SR-2 – ADVISORY STAFF REPORT (09-04-2026)

ADDRESS: 1120 SEMINOLE

APPLICATION NUMBER: HDC2026-00401

SCOPE: ERECT GREENHOUSE (WORK COMPLETED WITHOUT APPROVAL)

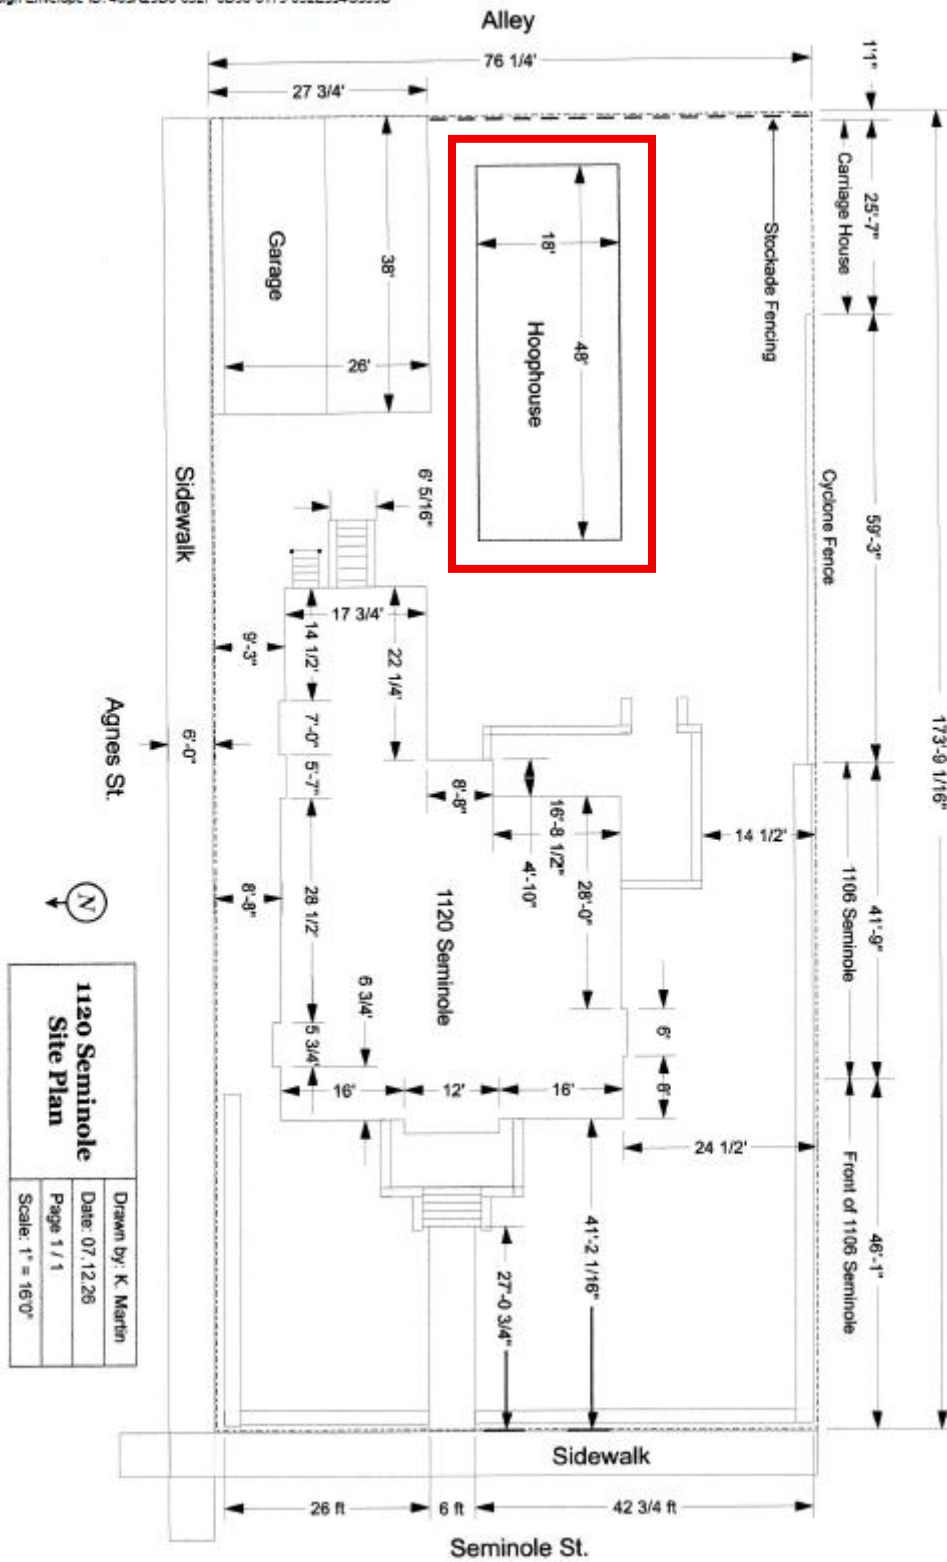
1. The scale of the hoophouse is not deferential to the scale of the house and size of the lot.
2. Design elements, such as the 12-foot-high Gothic arch roof, and the materials, such as plastic and metal tubing, are not compatible with the historic Colonial Revival house or the district.
